Project	IEEE 802.16 Broadband Wireless Access Working Group < http://ieee802.org/16 >	
Title	C802.16g-06/048r1	
Date Submitted	2006-09-28	
Source(s)	Ronald Mao Huawei Technologies Co.,Ltd.	Voice: 858-882-0335 Fax: 858-882-0350 rmao@huawei.com
Re:	C80216g_D4	
Abstract	Correction of Figure 474.	
Purpose	Adopt.	
Notice	This document has been prepared to assist IEEE 802.16. It is offered as a basis for discussion and is not binding on the contributing individual(s) or organization(s). The material in this document is subject to change in form and content after further study. The contributor(s) reserve(s) the right to add, amend or withdraw material contained herein.	
Release	The contributor grants a free, irrevocable license to the IEEE to incorporate material contained in this contribution, and any modifications thereof, in the creation of an IEEE Standards publication; to copyright in the IEEE's name any IEEE Standards publication even though it may include portions of this contribution; and at the IEEE's sole discretion to permit others to reproduce in whole or in part the resulting IEEE Standards publication. The contributor also acknowledges and accepts that this contribution may

Figure 474 Accounting primitives initiated by the NCMS

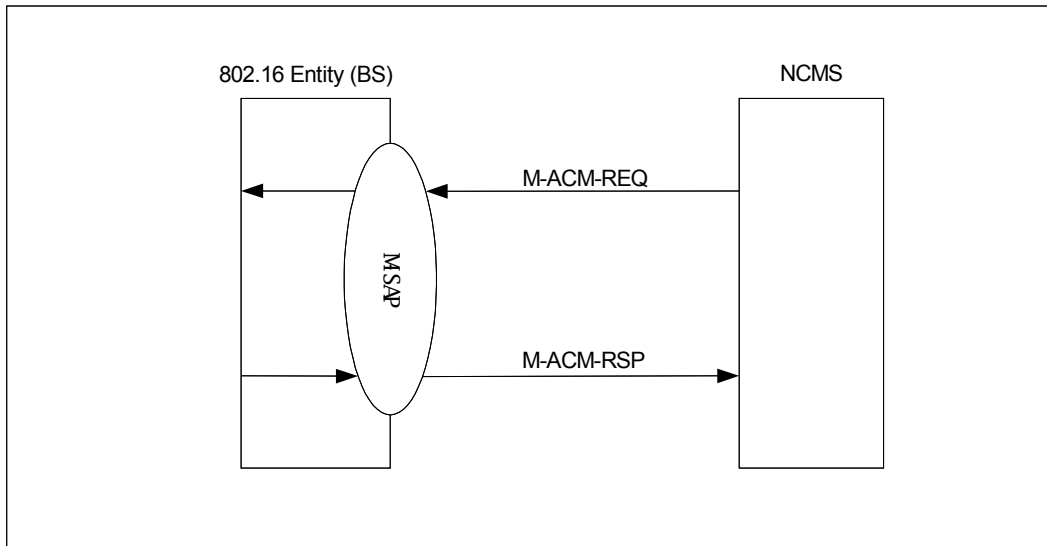
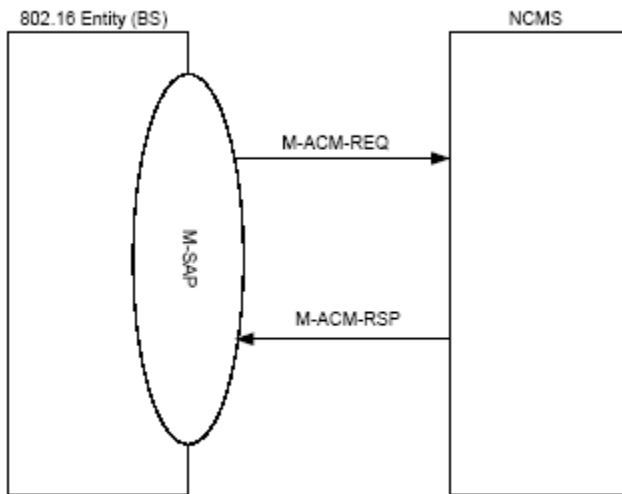
[Replace Figure 474 as follows]

Figure 474—C-SFM-REQ(Create) and C-SFM-RSP(Create) primitives flow, 802.16 entity initiated
